We request that you amend US Nuclear Regulatory Commission License Number SUC-1593 (docket number 040-9083) to correct the location of the Radiation Control Area at Donnelly Training Area, Fort Wainwright, Alaska.

We have enclosed "M101 Impact Areas," dated February 16, 2018, which should replace a similar document dated December 31, 2015 that is currently incorporated in the license by reference. The only change to "M101 Impact Areas" is the map on page 2.

SUBJECT: Request for Administrative Adjustment to Installation Specific Archive Search
Report on the Use of Cartridge, 20mm Spotting M101 Davy Crockett light Weapon M28 at
Fort Greely, Alaska, October 2008

SUBJECT: Analysis to Support Administrative Adjustment to Installation Specific Archive Search Report on the Use of Cartridge, 20mm Spotting M101 Davy Crockett light Weapon M28 at Fort Greely, Alaska, October 2008

Fort Knox KY

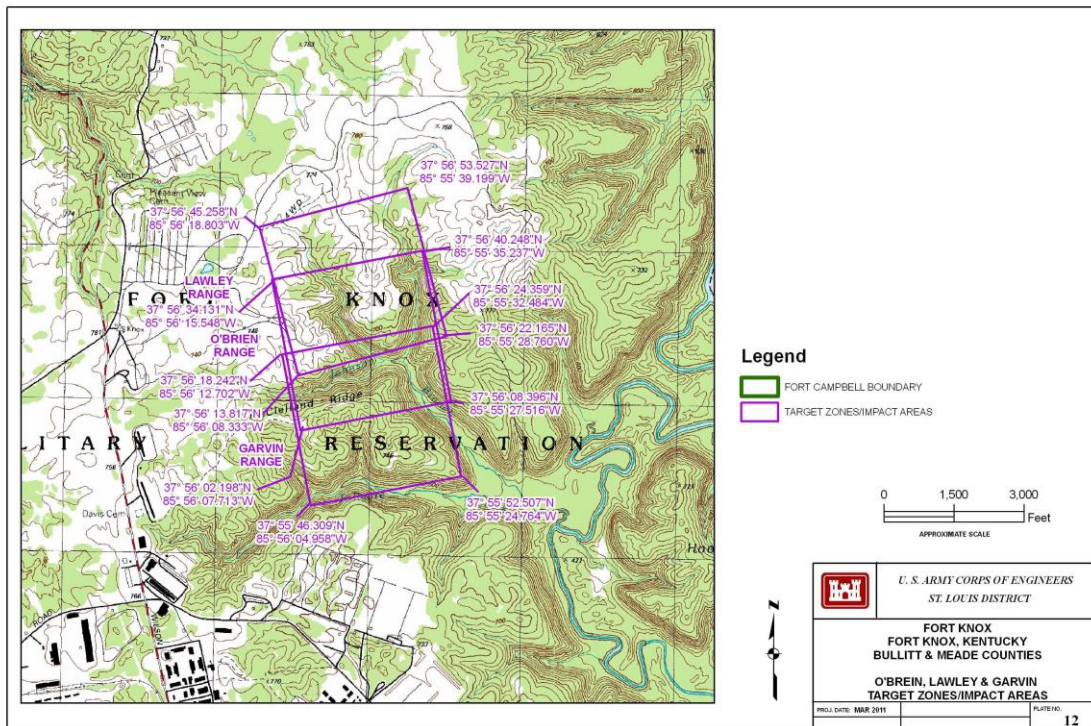
The legend should read "FORT KNOX BOUNDARY"

M101 firing was on the O'Brien (aka O'Brein) Range.
The legend should read "FORT KNOX BOUNDARY."

Joint Base Lewis-McChord/Yakima Training Center WA

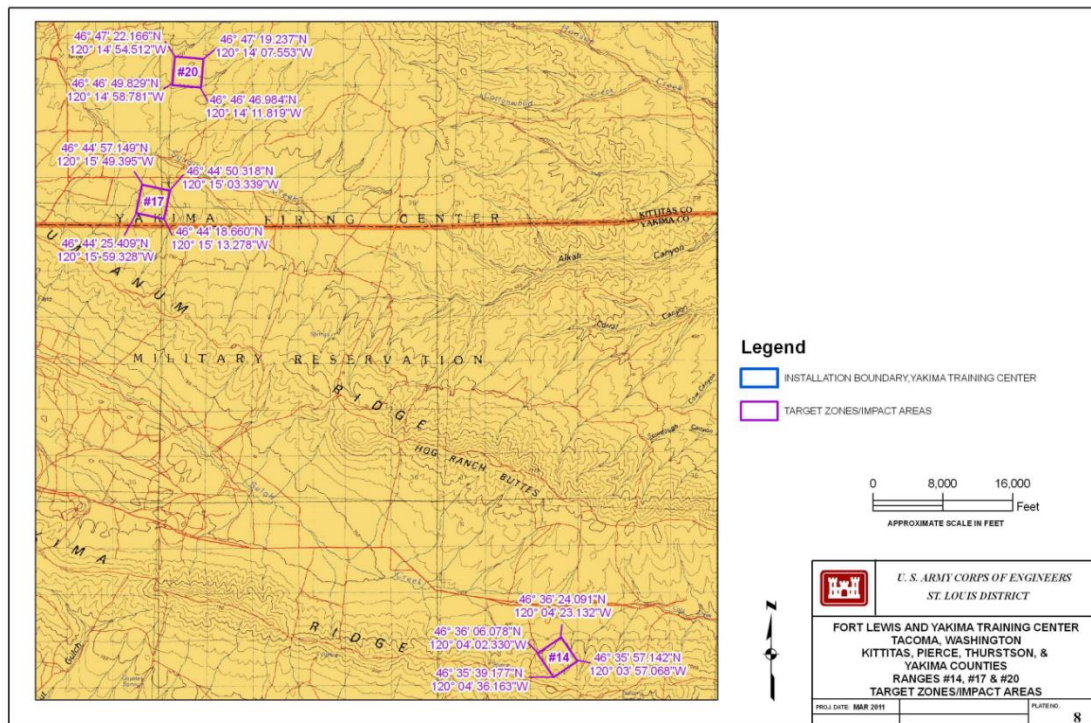
Range 53 is not an M101 impact area; range 52, OP8 and OP9 are M101 impact areas

The westing coordinate for the west corner of Range #14 should read "120° 05' 02.330" W."

Overlay of Historic maps from 1962 and 1975 with annotated coordinates

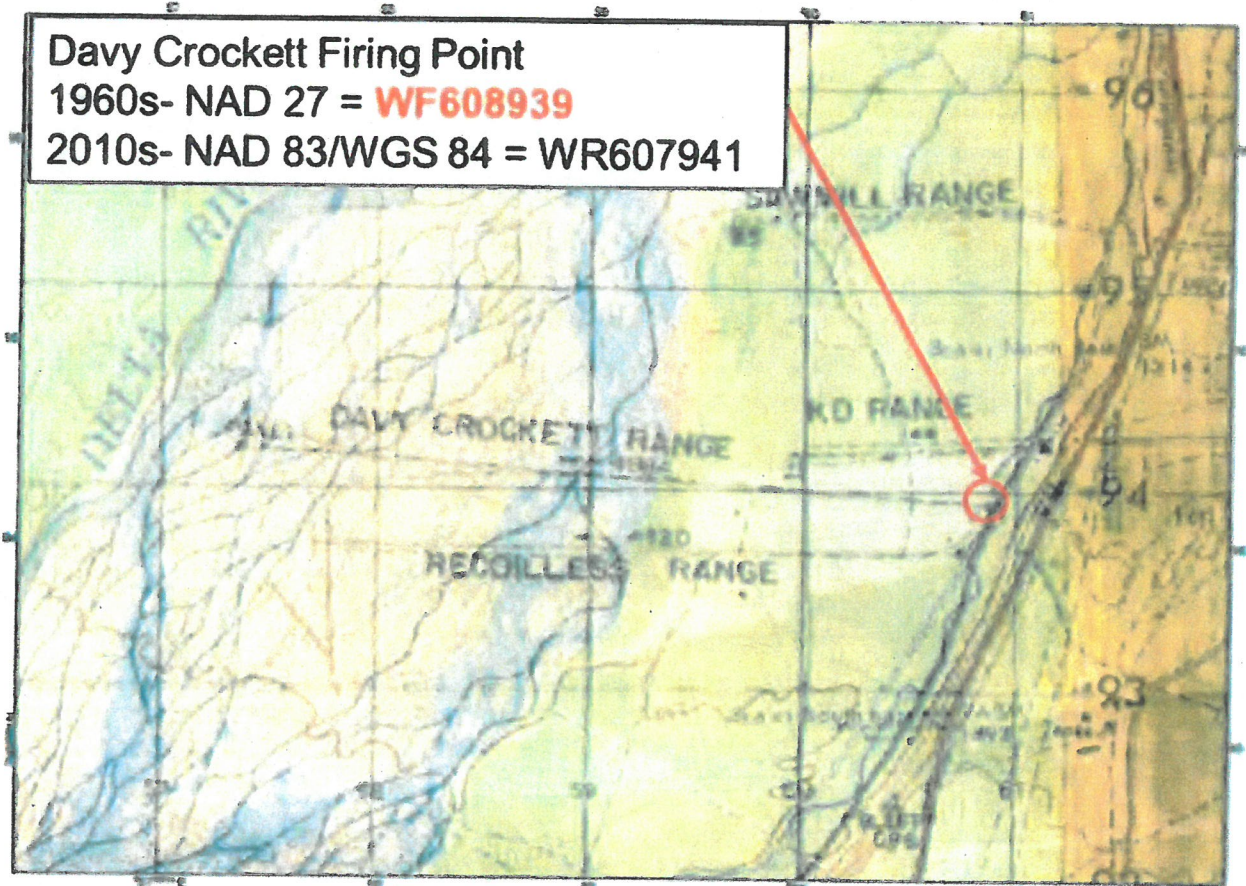
g. Enclosure 7 is a correlation of the two map references (Enclosure 4 & 5) and a plot of the firing point grid from the Land Use Study (Enclosure 6). All three references are based on the NAD27 map datum. As shown on the map the grid called out in the land use study matches the plot of the firing point on the map.

NOTE: This picture is a graphical overlay of the 1962 and 1975 maps and then using the information from the Land Use Report plotting the actual location of the firing point for the Davy Crockett Range. This used three separate data points to confirm the location. The grid coordinate was then converted from the original map datum (NAD27) to the current map Datum (NAD83/WGS84).

Photograph taken from the Installation Specific ASR – Fort Greely, Cartridge, 20mm Spotting M101, Davy Crockett Light Weapon M28, Figure 7, page 12.

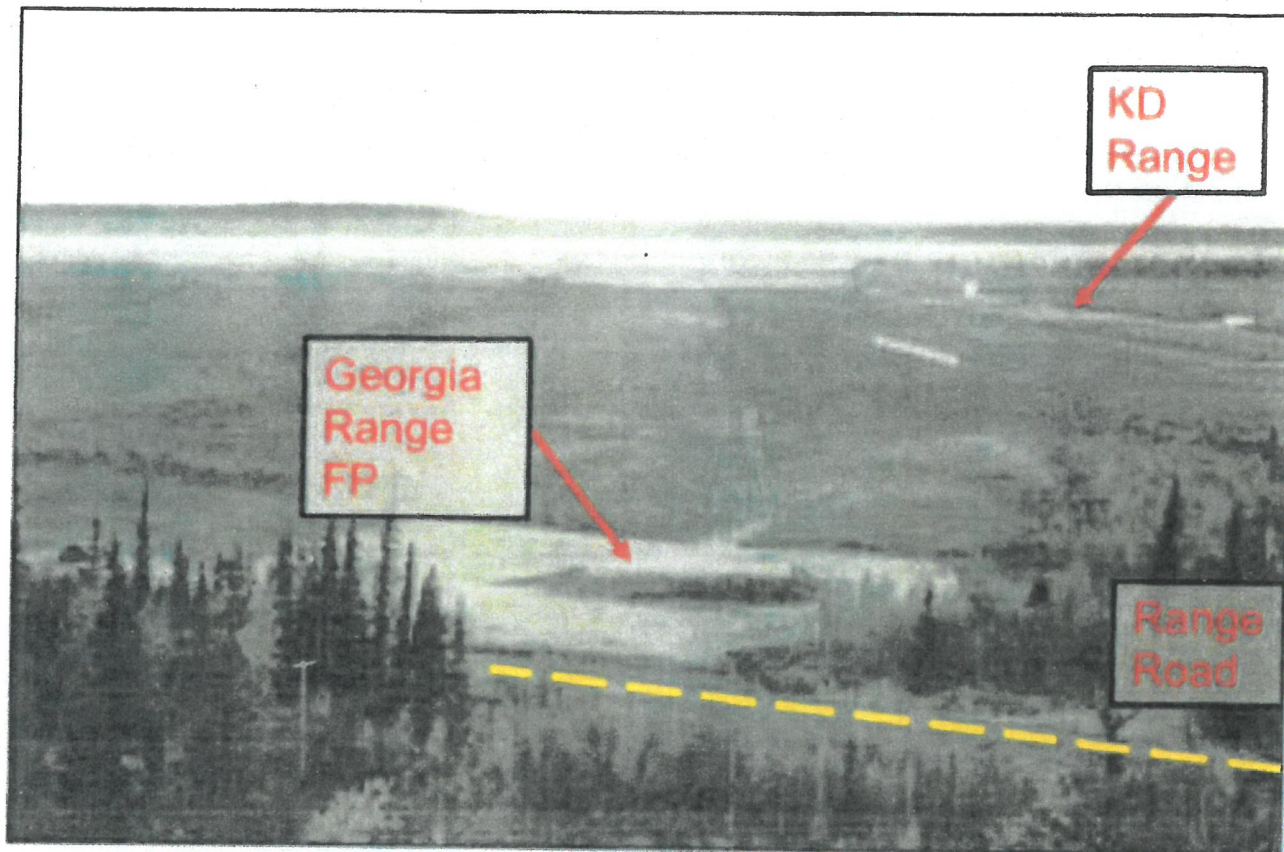
e. The mapped location of the firing point in the final report has it located to the East of the Range Road. The picture at Enclosure 8 (taken from Figure 7 of the report) clearly shows the firing point to the West of the road.

h. Enclosure 8 is a historical photo of Georgia Range. It appears in Figure 7 and Figure 9 of the report. The picture has been annotated with some key terrain features to assist in geo-referencing this to maps and other imagery. This picture clearly shows that the firing point is on the West side of the Range Road.

NOTE: Annotations were added to the picture to provide clarity on what is seen in the picture. The locations of the firing point in relation to the KD Range, as described in the Land Use Study, is correlated with this photo. Again, note that the firing point is on the West side of the Range Road.

Extract from Plate 4 from the report – Annotated with documented reference points

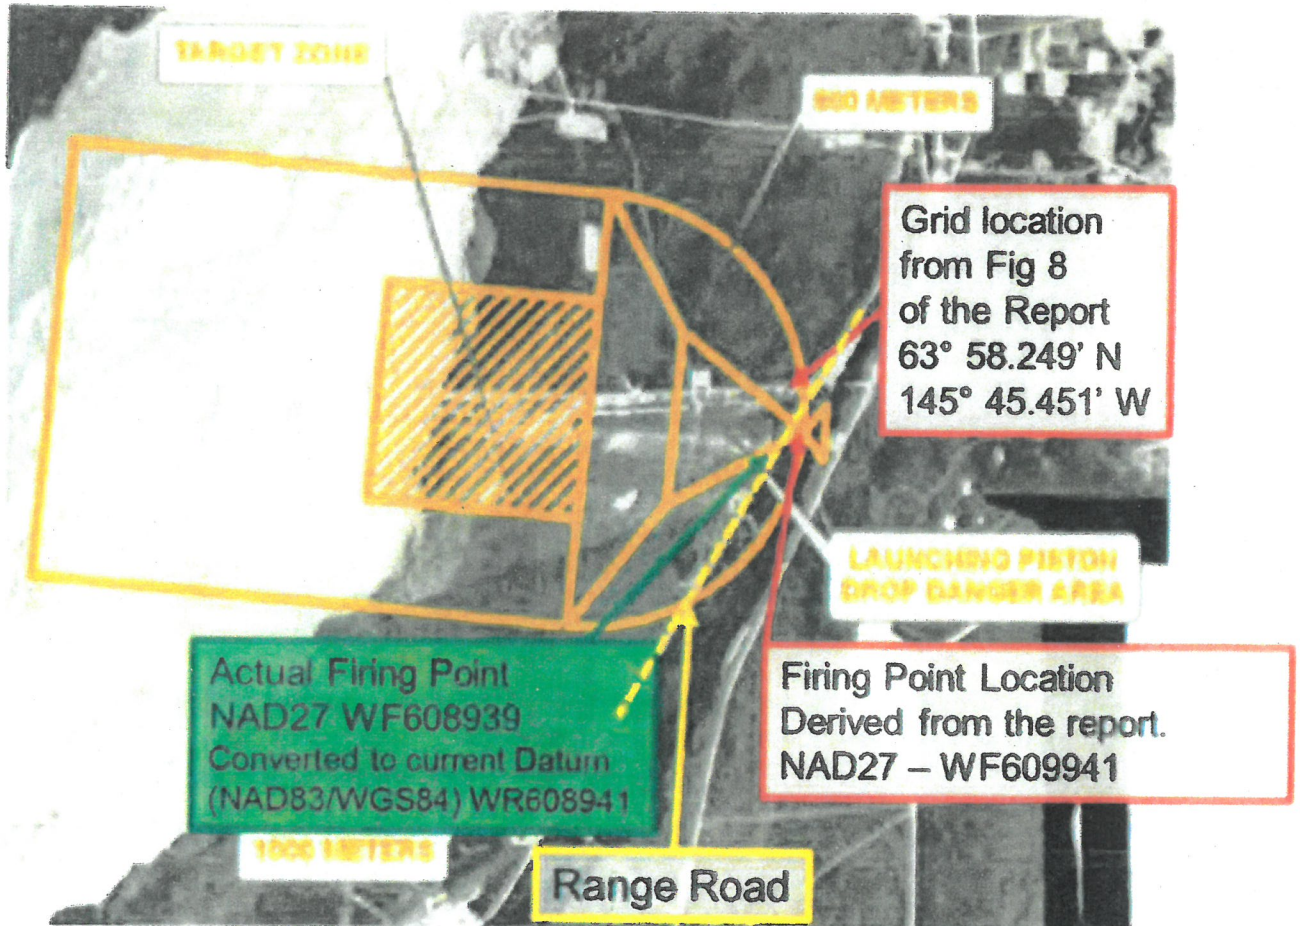
j. Enclosure 10 is an extract from Plate 4 of the report. Using geo-referencing we have plotted several key points. First is the grid location based on the picture in Figure 8, this clearly plots on the KD Range. The second location is the plotted location of the firing point contained in the report and used in determining the potentially contaminated area. Third, is the actual location of the firing point based on the Land Use Study.

NOTE: Based on ortho-correcting the imagery and geo-referencing them with the map information from the time of the range we were able to derive the actual location for the firing point. The actual firing point is over 200 meters away, further to the South and West from what is currently in the report

Comparison of Surface Danger Area Diagrams (SDAD) for both locations

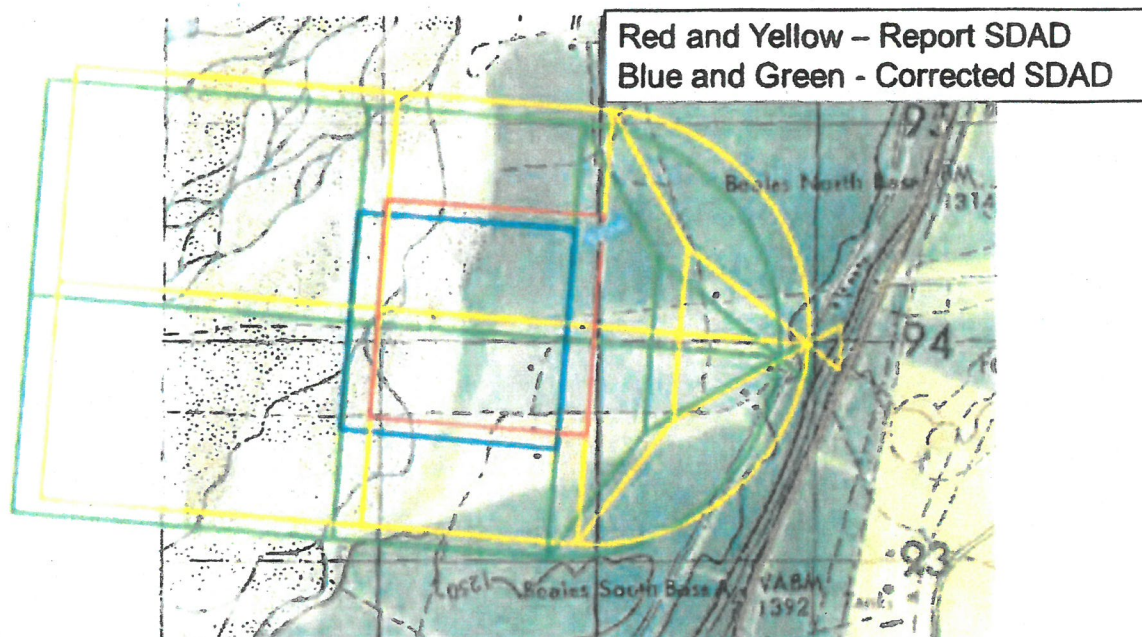
k. Enclosure 11 is a comparison of the SDAD plot contained in the original report and the corrected plot based on the additional information and our GIS analysis.

NOTE: The diagram in yellow with the red target area box is from the original report.
The diagram in green with the blue target box area depicts the corrected location.

The corrected SDAD geo-referenced to 2015 imagery.

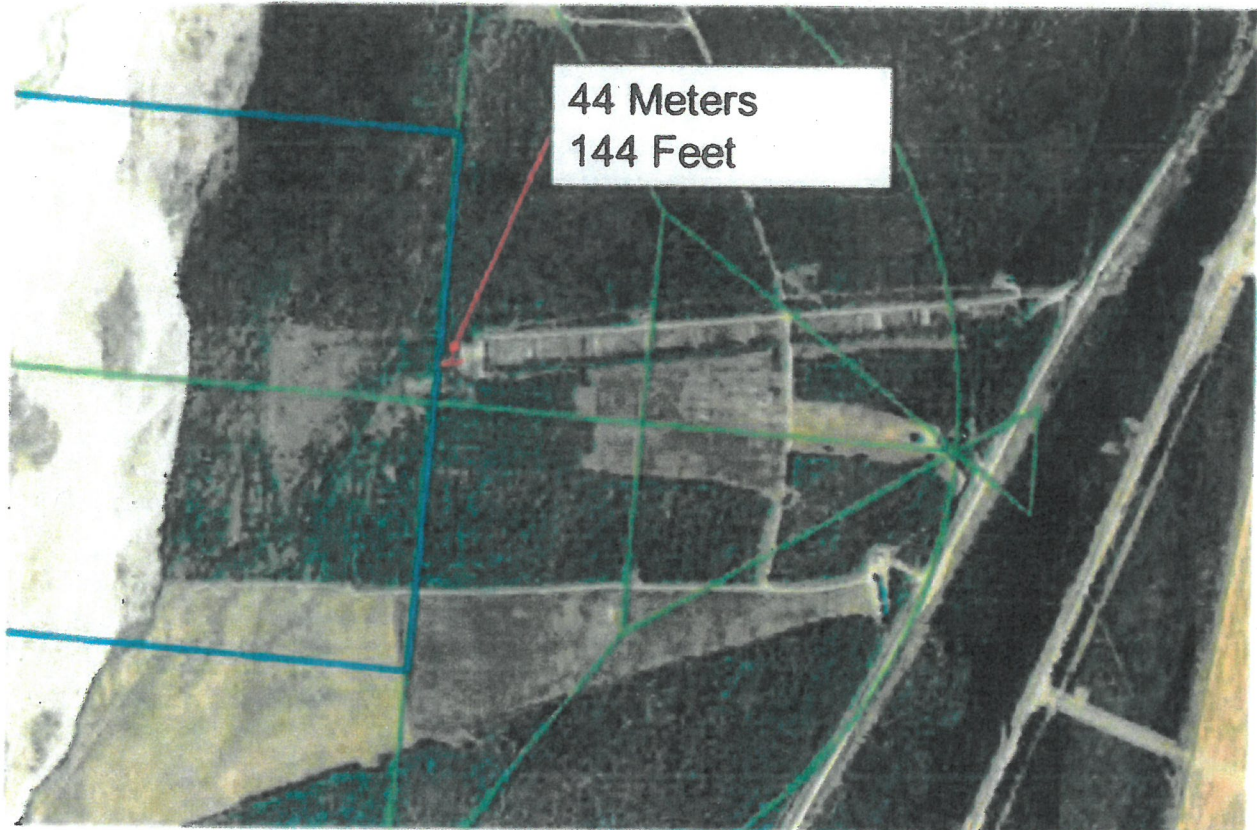
l. Enclosure 12 is a close up view of the corrected SDAD overlaid on the most current imagery. This show that the current location of the KD range DOES NOT fall within the designated DU target area.

NOTE: The corrected SDAD shifts the eastern edge of the target box to the West. As a result the closest point of the target box to the KD range is 144 ft west of the end of the KD Range.

The corrected SDAD overlaid on the original 1962 map.

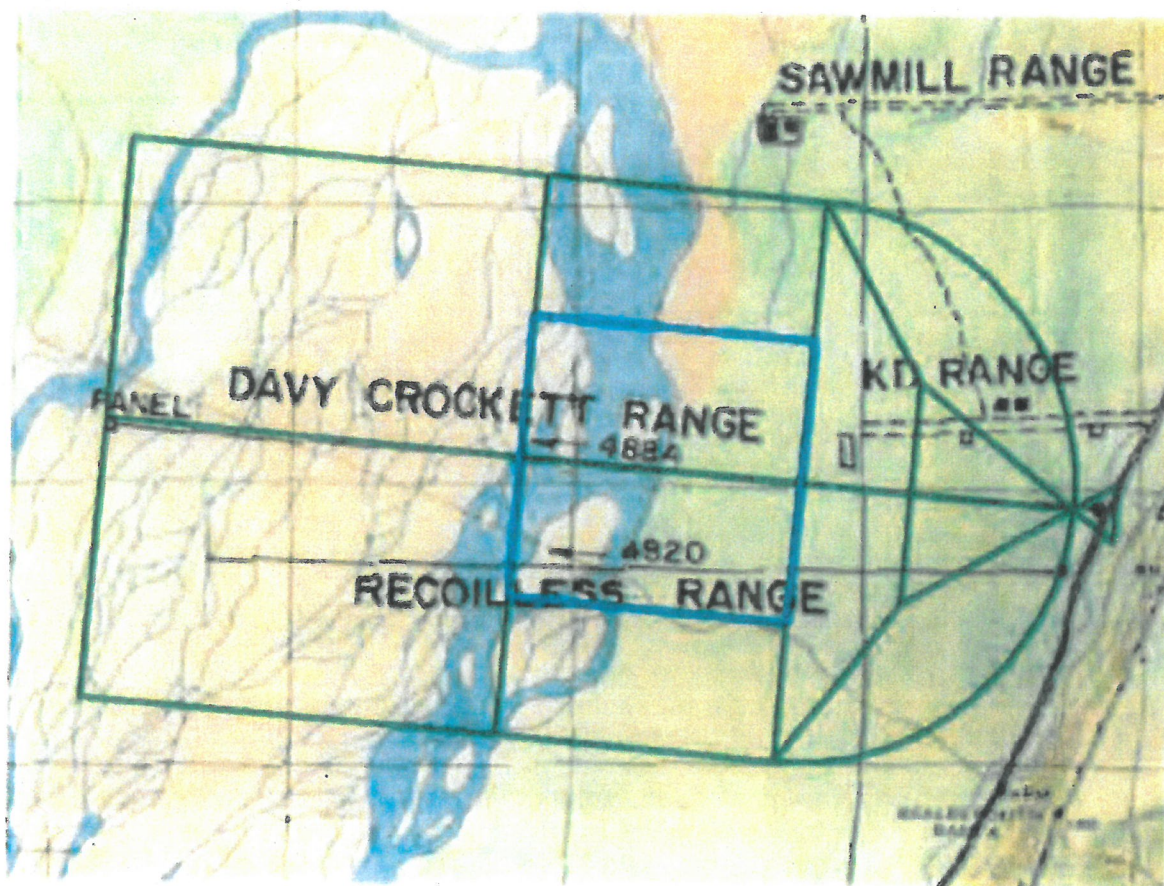
m. Enclosure 13 is a geo-referenced plot of the corrected SDAD over the 1962 map plot for the range. This shows an almost perfect correlation with the corrected SDAD.

NOTE: This diagram is a plot of the corrected SDAD and the original map plot of the range in 1962. This validates the corrected SDAD as being true and accurate based on all information gathered.

REVISION TO PLATE 2

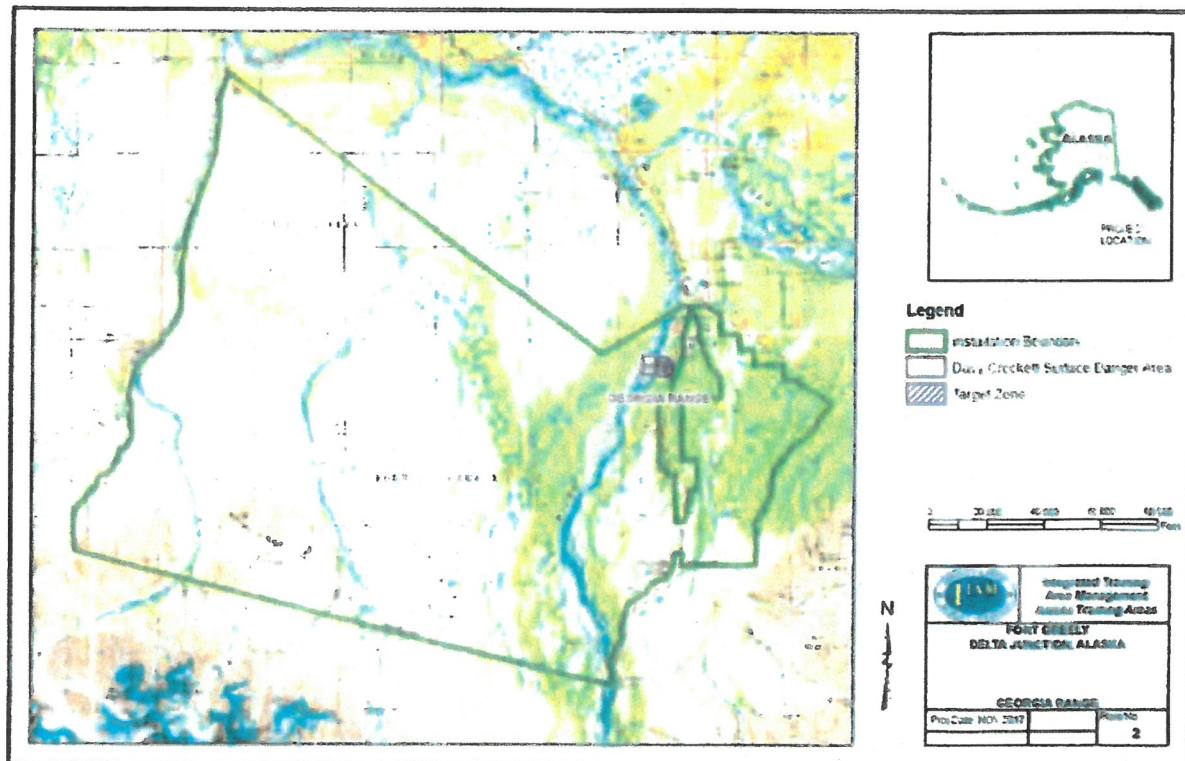
n. Enclosures 14 – 19 are the revisions to the plates in Appendix I of the report based on the corrected version of the SDAD. The specific changes to the LAT/LONG for the corrected box are listed as well as on the diagram.

REVISION TO PLATE 4

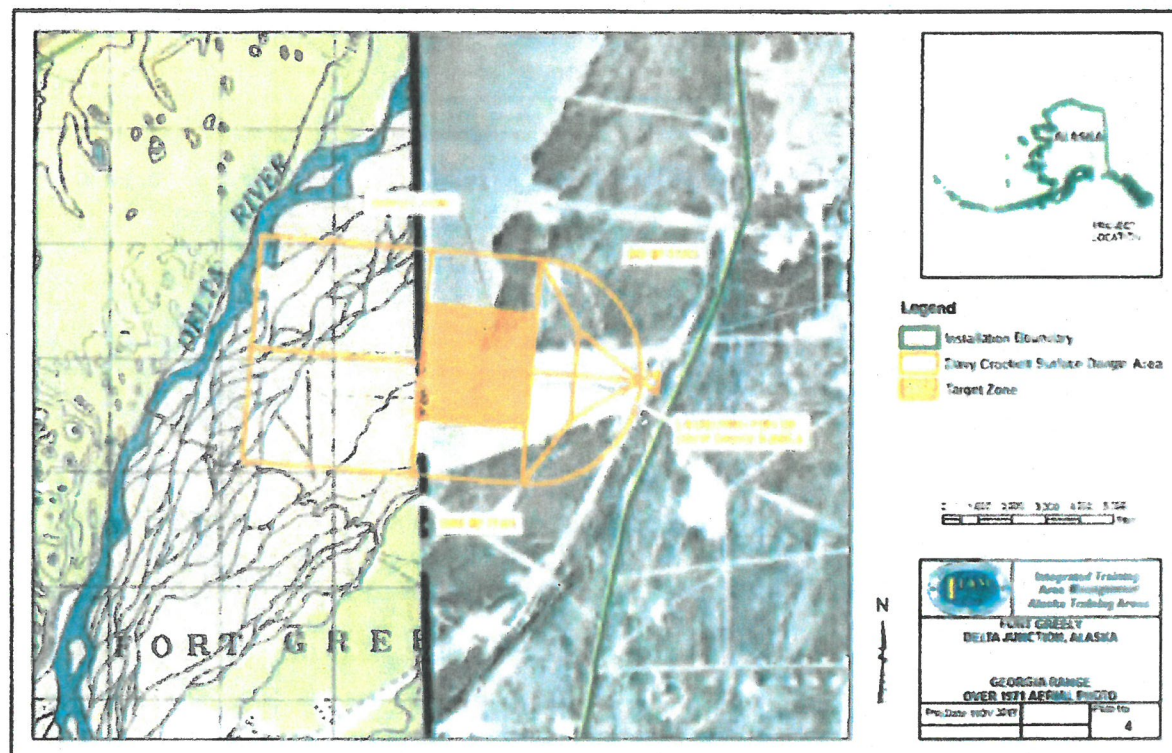
f. The plot of the firing point on the map in Figure 6 (and Appendix I-7) in the report does not correlate to the Surface Danger Area Diagram as plotted on Plate 4 in Appendix I of the report.
